[Upgrade to Revision]

R20TS0771EJ0100

RH850 Model-Based Development Environment,
 Embedded Target for RH850 Multicore + Multirate V5.02.00,
 Embedded Target for RH850 Multicore V5.02.00,
 Embedded Target for RH850 V5.02.00

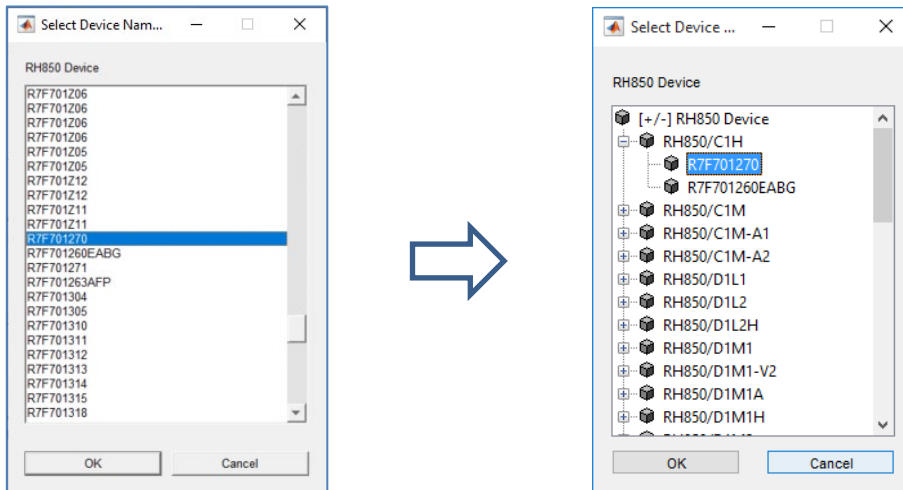
The main changes are as follows.

2.1 Improved Functionality

(1) Changes in the operating environment

V5.01.00	V5.02.00
MATLAB® (MathWorks)	R2016a to R2018b	R2016a to R2019b
MEX-file compiler	Refer to the web page below for supported versions. Support - System Requirements and Supported Compilers Previous Releases - MATLAB & Simulink (mathworks.com)	
CS+	V7.00.00, V8.01.00	V8.05.00, V8.06.00
CC-RH compiler	The compilers included in above	The compilers included in above
CCRH850 compiler (Green Hills Software)	Version 2015.1.7 or 2018.1.5	No change
Cycle-accurate simulator	RH850/C1x and other simulators	Added RH850/C1M-A1 and RH850/F1KH
eMBP (eSOL)	Ver.2.0.0	Ver.2.2.2
RH850 processor element communication and exclusive control library	Download from the web page	Included in the product package
